Tank Car Inboard Stub Sill Inspection and Modification

INSPECTION BULLETIN

October 7, 2020

FIGURE 2

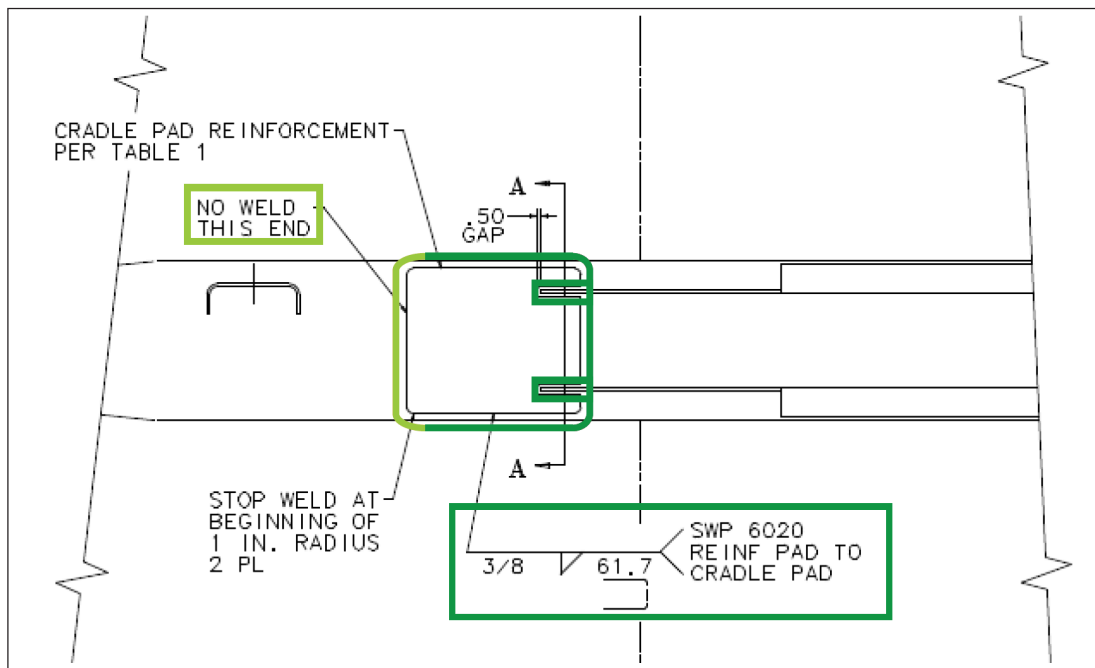
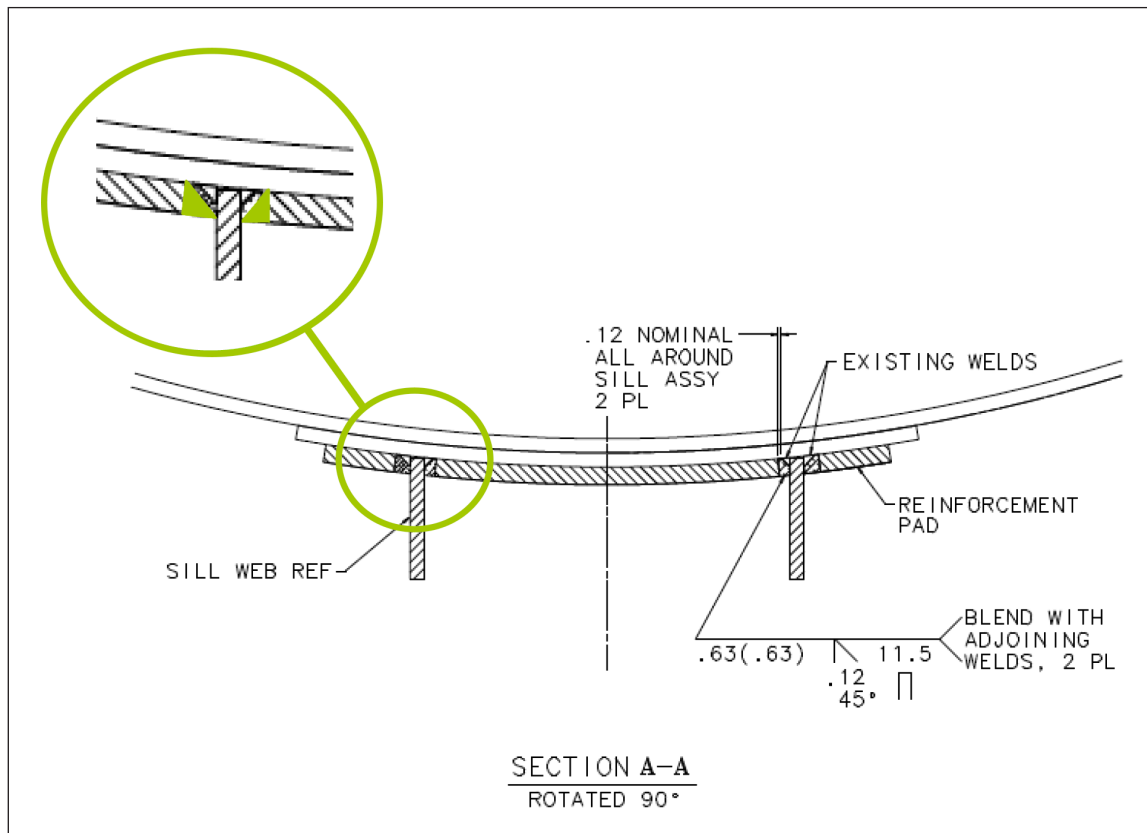
3. Position the cradle pad reinforcement as shown (Figure 2.) The reinforcement may require grinding or trimming to maintain the proper weld joint geometry shown in Figure 2; the weld preparation should be 1/2 inch wide minimum around the draft sill side webs, to allow for the application of a 5/8 inch groove weld.

4. Weld the cradle pad reinforcement to the draft sill and cradle pad per Figure 2, using an E-7018 electrode or equivalent. All Welding is to be in accordance with AWS D15.1, and the AAR Manuals of Standards and Recommended Practices Appendix W.

DO NOT WELD THE INBOARD TRANSVERSE END OF THE REINFORCING PAD.

FIGURE 3

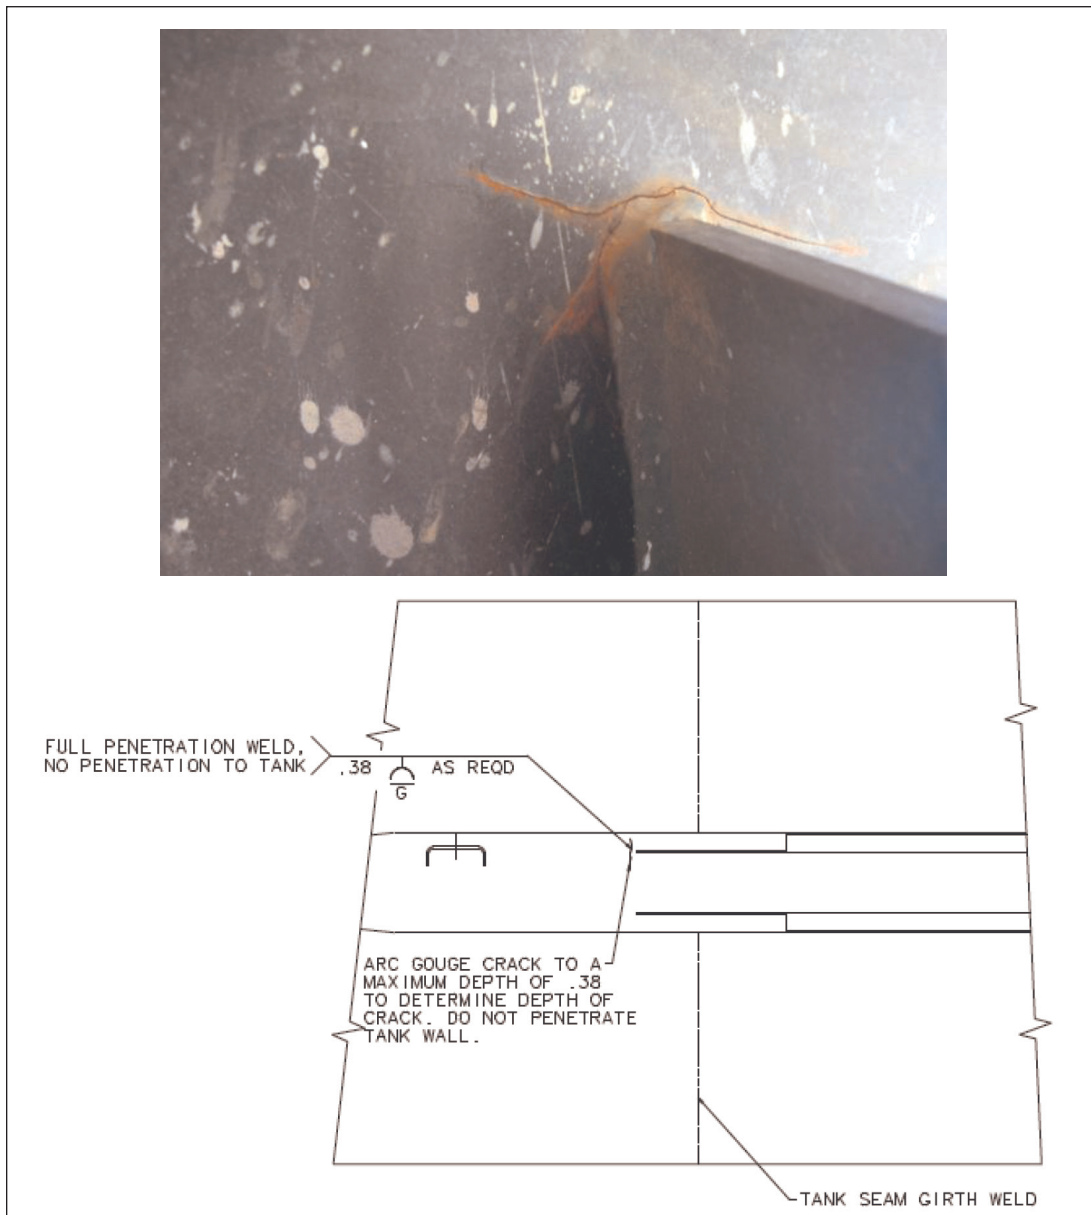
- i. Dye Penetrant inspect the full length of the crack removal area to ensure the crack has been completely removed.
- ii. Weld repair the crack by groove welding, ensuring that there is no penetration to the tank shell (Figure 3.)
- iii. Welding is to be performed using an E-7018 electrode or equivalent. All Welding is to be in accordance with AWS D15.1, and the AAR Manuals of Standards and Recommended Practices Appendix W.
- iv. Grind the weld flush with the cradle pad surface.

FIGURE 4

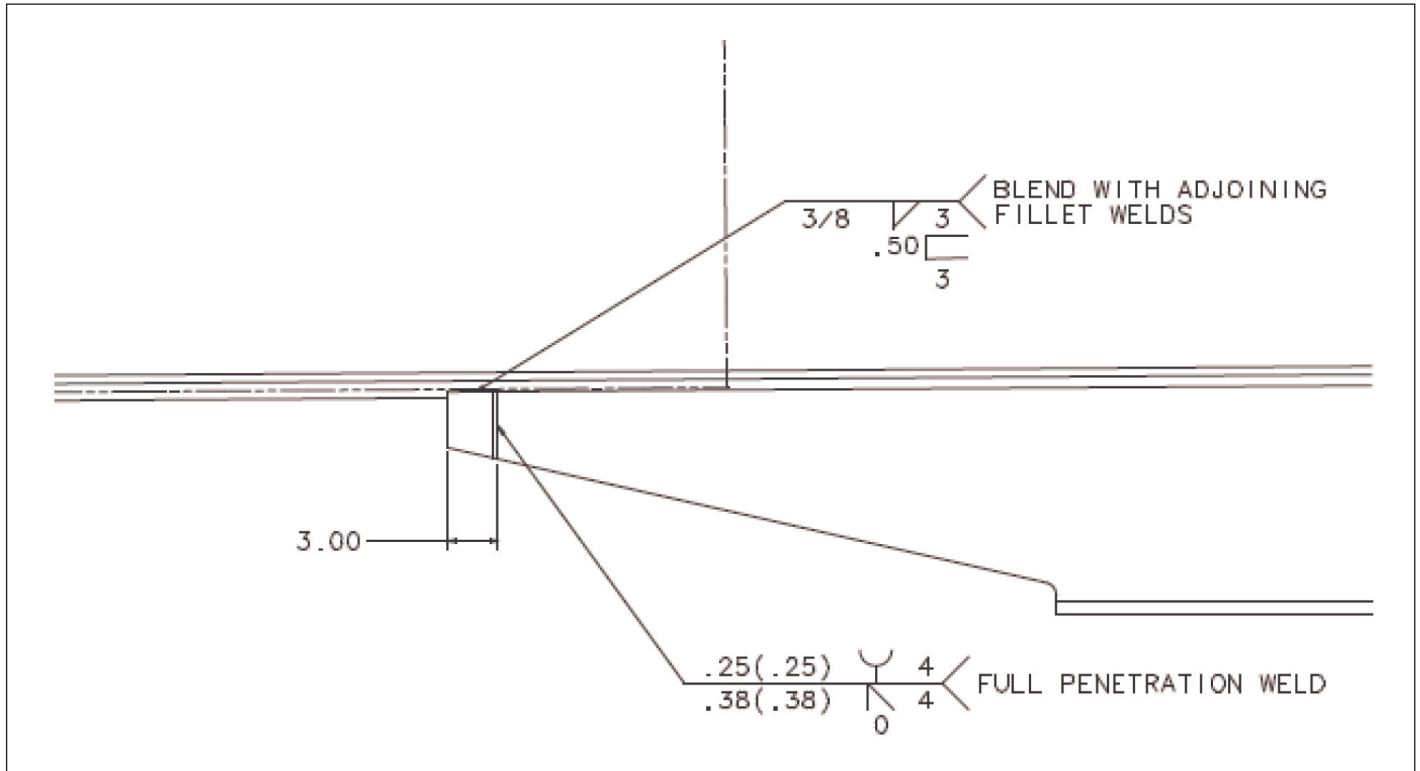
- v. Apply a 3 inch x 4 inch x ½ inch ASTM A-572 Gr. 50 draft sill web extension to each side of the inboard end of the sill webs per Figure 4.
- vi. Apply the cradle pad reinforcement per Modification 1 of this Inspection Bulletin.

FIGURE 5

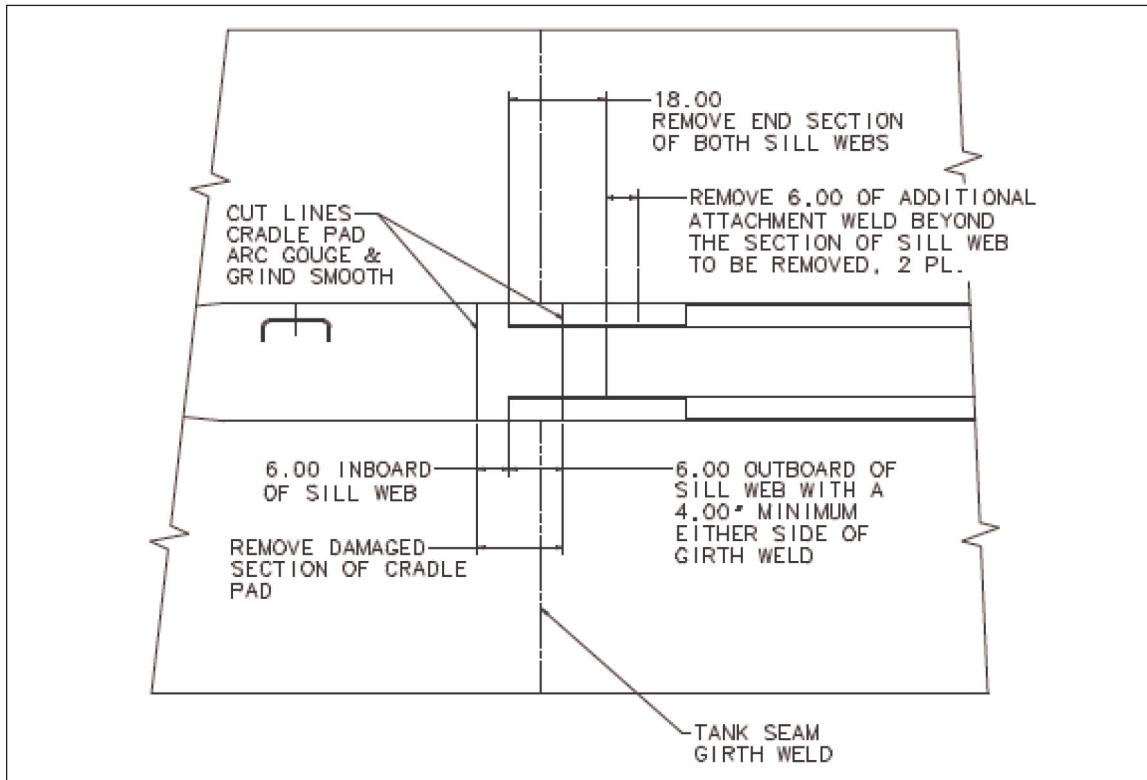
- i. Arc gouge or flame cut, to remove 18 inches of the stub sill vertical side webs, per Figure 5. Save for reapplication.
- ii. Cut back the longitudinal attachment welds from the draft sill webs to the cradle pad approximately 6" longer than section of draft sill side webs to be removed.
- iii. Remove the damaged section of cradle pad by arc gouge, being careful not to damage the tank (Figure 5.)

The cradle pad should be removed with the outboard transverse weld seam located 10" outboard of the former draft sill termination location; this location may need to be extended outboard to ensure the cut location is at least 4" from the tank girth weld.

The inboard cut line is to be 6 inches inboard of the former draft sill termination location.

FIGURE 6

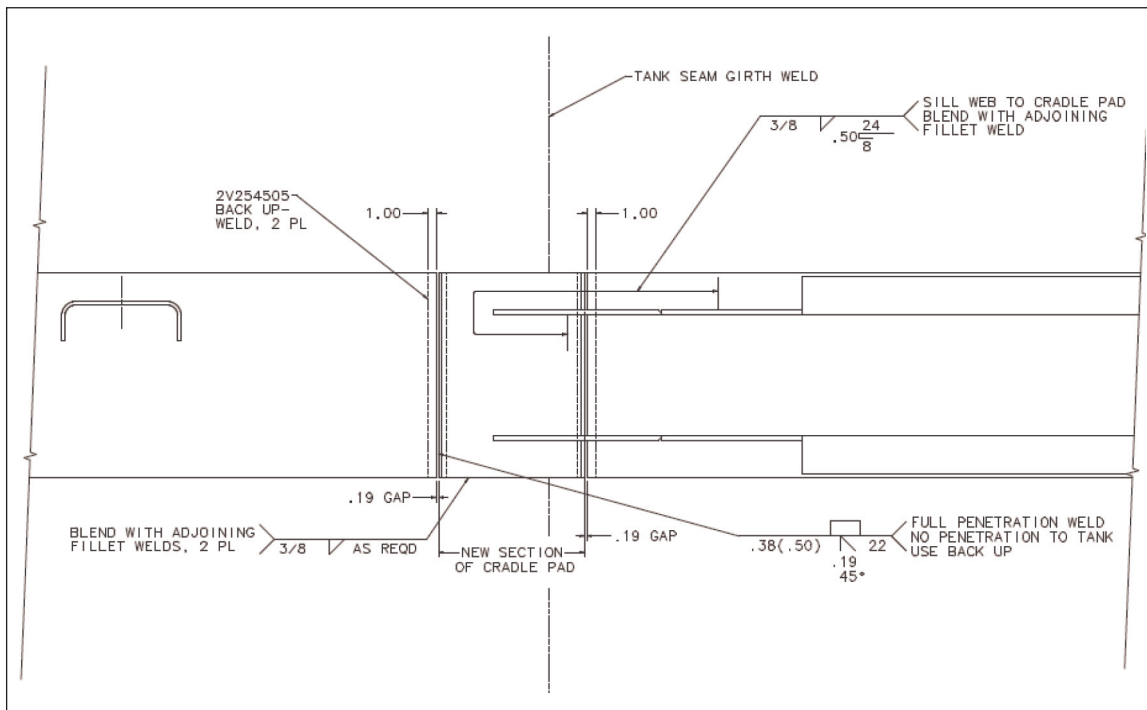
- viii. Fabricate a cradle pad splice in the same thickness as the removed cradle pad; material is ASTM A572 Gr. 50 modified to 70,000 psi tensile and rolled to match tank diameter. Apply weld prep on the transverse edges of the cradle pad splice as shown in the weld in Figure 6.

- ix. Groove weld the cradle pad splice section into place per Figure 6. The transverse welds are to be full penetration groove welds using the backing applied in 2.B.vi above to prevent penetration to the tank. Fillet weld the longitudinal edges of the cradle pad to the tank with 3/8 inch fillet welds including the 6 inch tie in created at the original cradle pad on the inboard and outboard ends of the cradle pad splice.

FIGURE 7

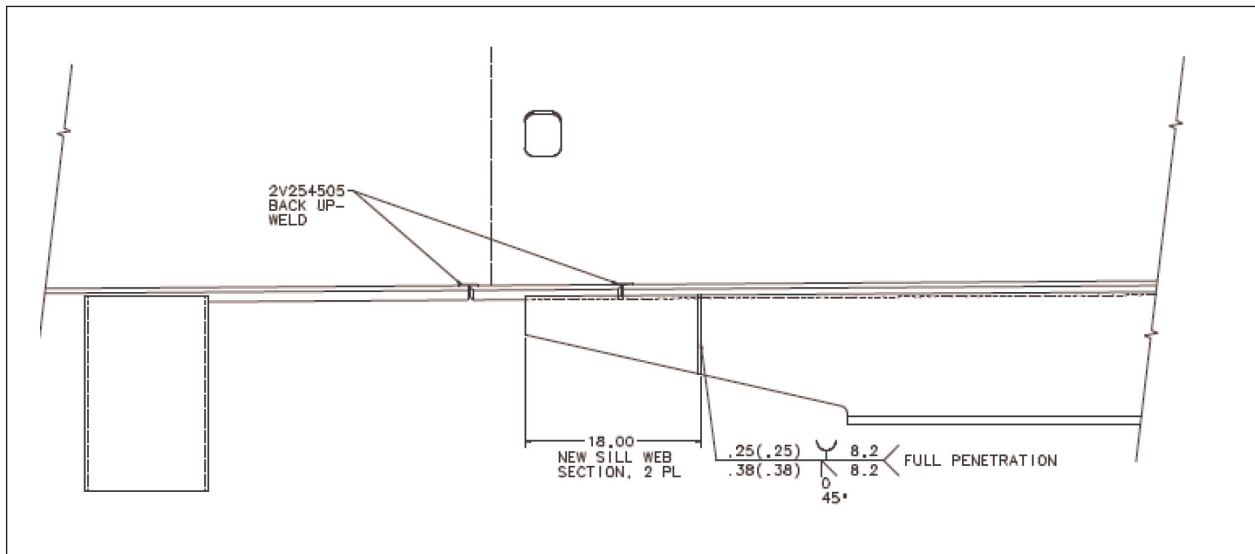
- xi. Local post weld stress relieve welds to tank shell.
- xii. Inspect the repair welds after stress relief with Dye Penetrant.
- xiii. Re-apply the draft sill side web sections removed in part 2.B.i. 100% penetration butt weld the vertical weld joint per Figure 7.
